P&Z CASE # SP2021-025 P&Z DATE 10/12/21 CC DATE _____ APPROVED/DENIED _____
ARCHITECTURAL REVIEW BOARD DATE _____ HPAB DATE _____ PARK BOARD DATE _____

PROJECT NUMBER: SP2021-025
PROJECT NAME: Site Plan for St. Benedict Church
SITE ADDRESS/LOCATIONS: 1500 SUNSET HILL DR, ROCKWALL, 75087

09/22/2021: SP2021-025; Site Plan for St. Benedict's Church

TO: Planning and Zoning Commission
DATE: October 12, 2021
APPLICANT: Dub Douphrate; *Douphrate & Associates*
CASE NUMBER: SP2021-025; *Site Plan for St. Benedict's Anglican Church*

LANDSCAPING PLAN

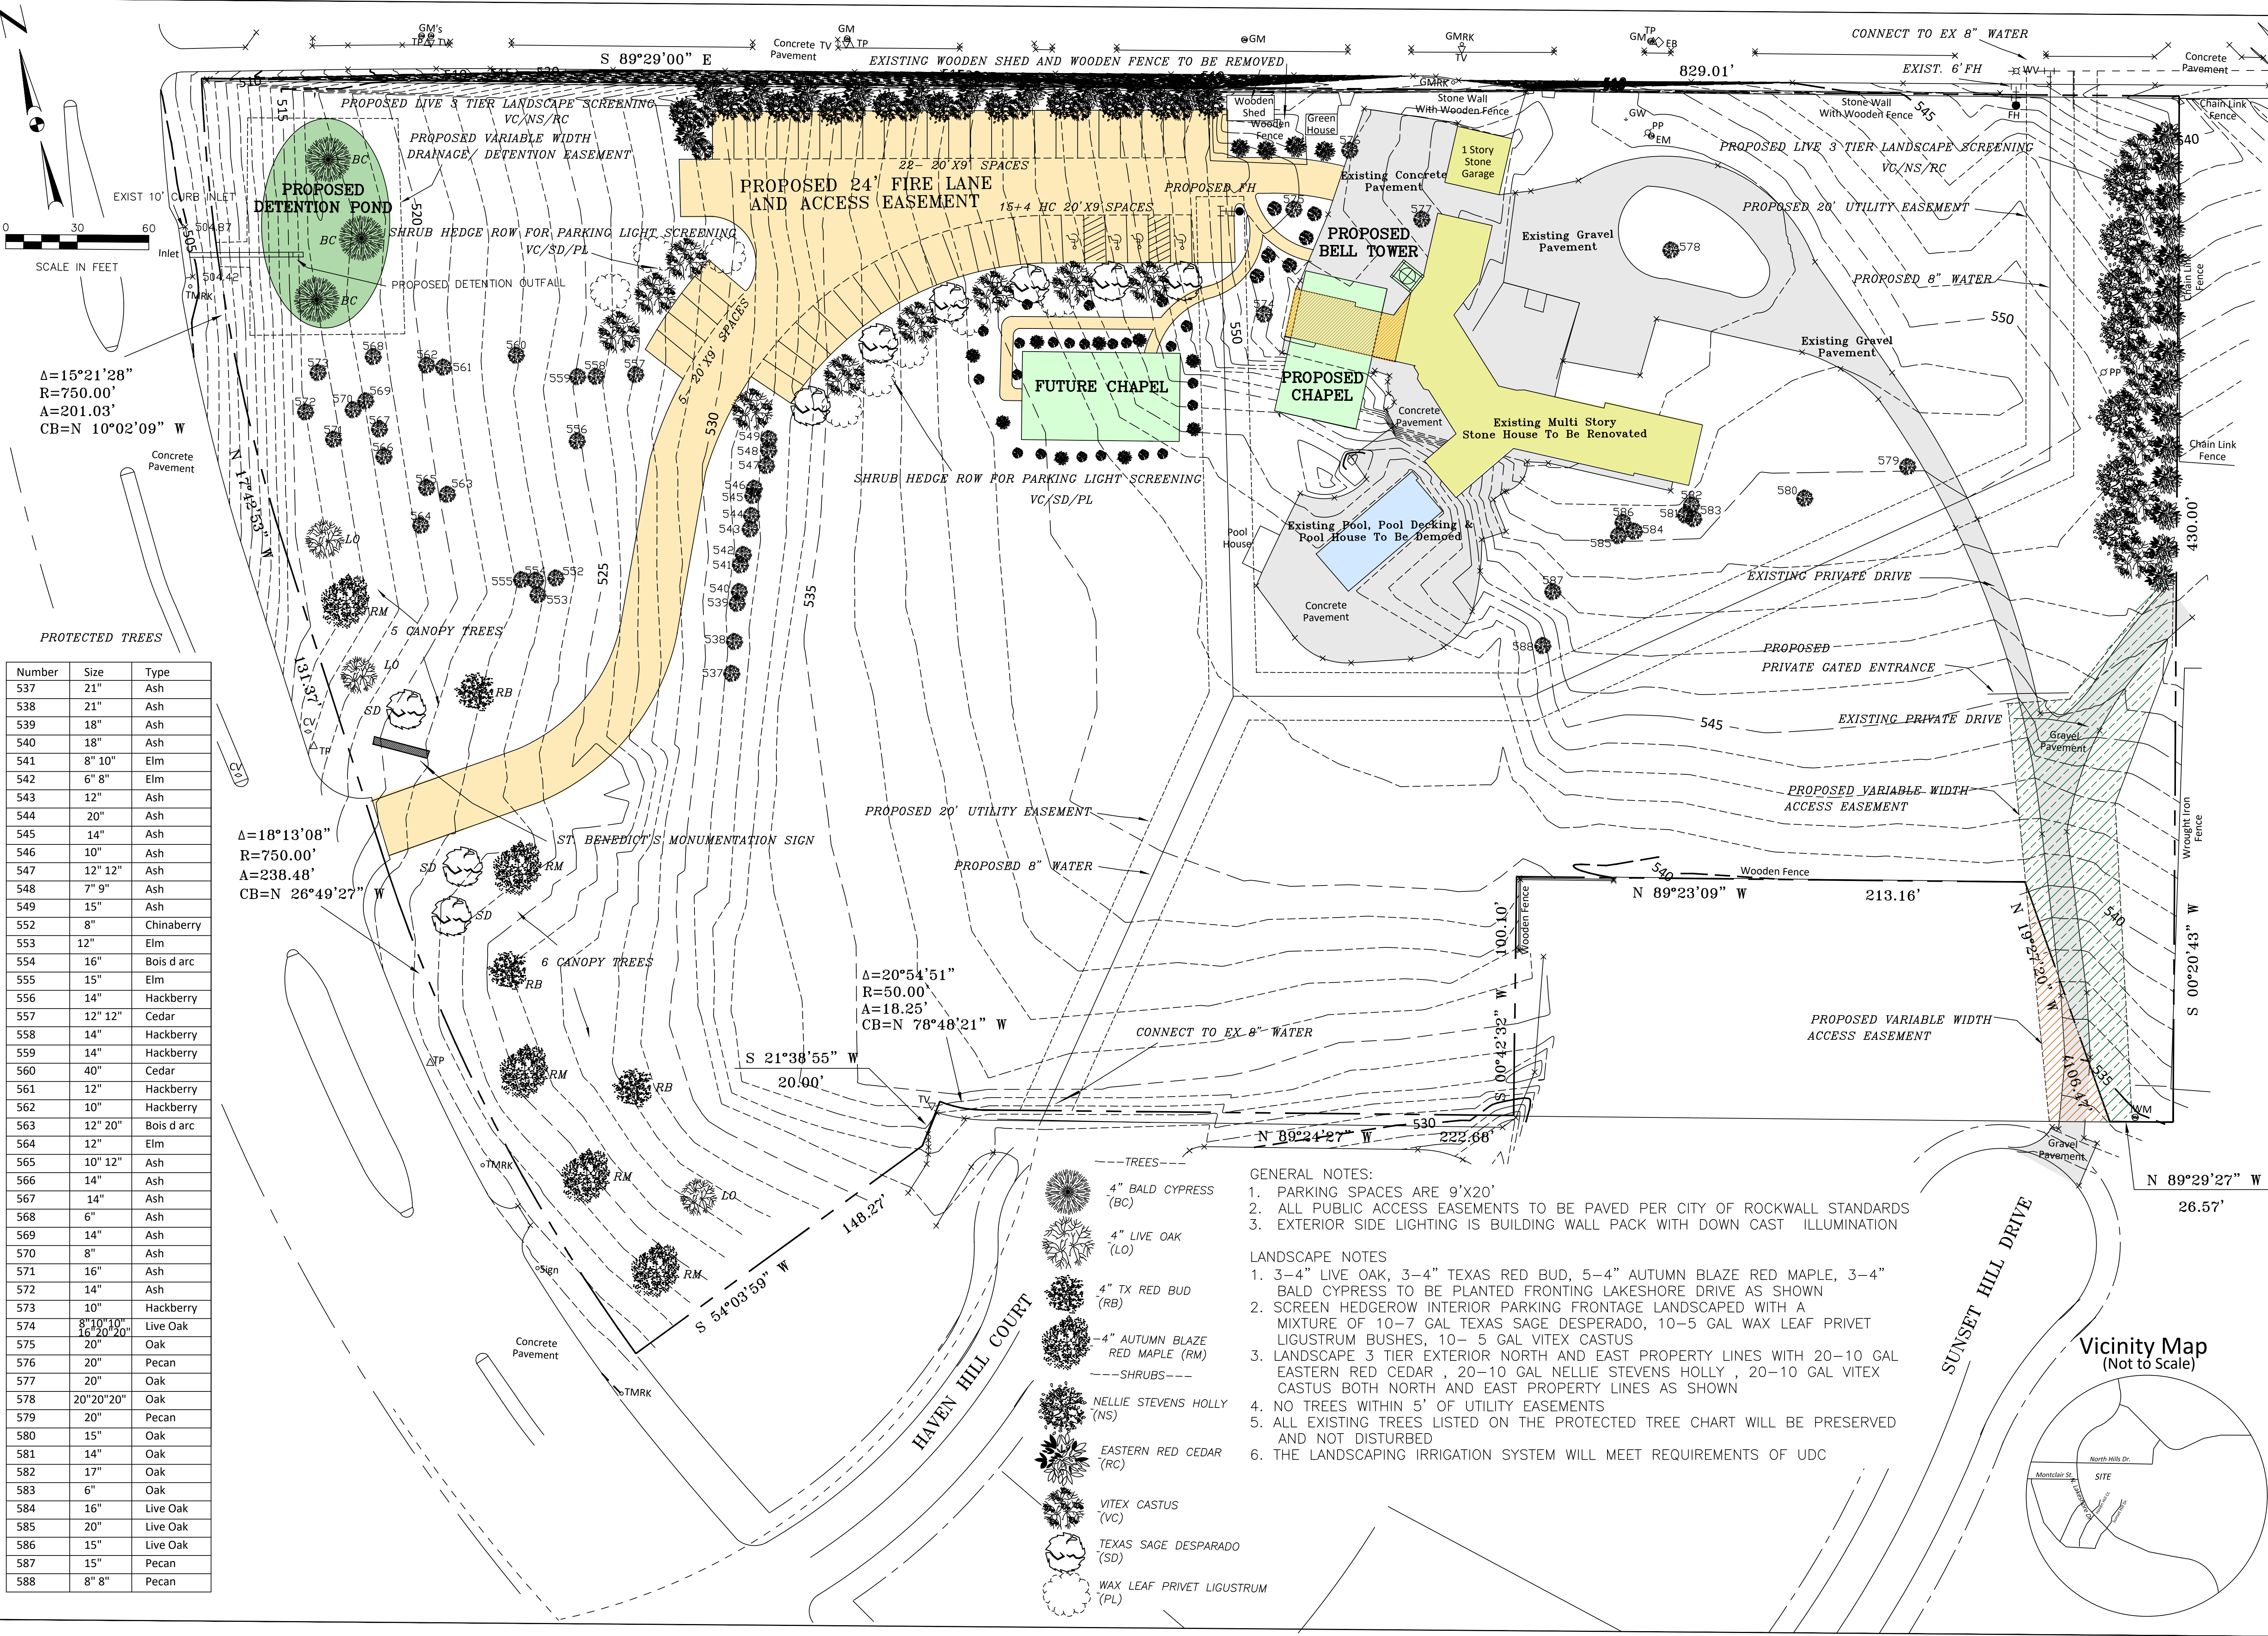
M.9 Landscape Plan:

1. Provide the same site data information required in Section 2.1 Site Plan: Miscellaneous and Density and Dimensional Requirements of this checklist. (Section 2.1 of this checklist)
2. Show the percentage for the impervious coverage. (Subsection 01.01, B. of Article 05)
3. Indicate all landscaping required by the SUP (S-205) 3-tiered screening along the north property line as described in M.7.14 and the shrubs along the parking area for headlight screening. The shrubs should connect to the 3-teir screening to the north to screen the headlights shining west from the fire lane. (Subsection 05.03, B. of Article 08)
4. Indicate the landscape buffer along N. Lakeshore Drive, which includes a berm and the canopy and accent trees. (Subsection 05.01, of Article 08)
5. All parking should be within 80-feet of a canopy tree (Subsection 05.03, E. of Article 09)

M.10 Treescape Plan:

1. If any trees are to be removed, include them on the landscape plan and indicate the mitigation balance. (Subsection 03.01, G. of Article 09)
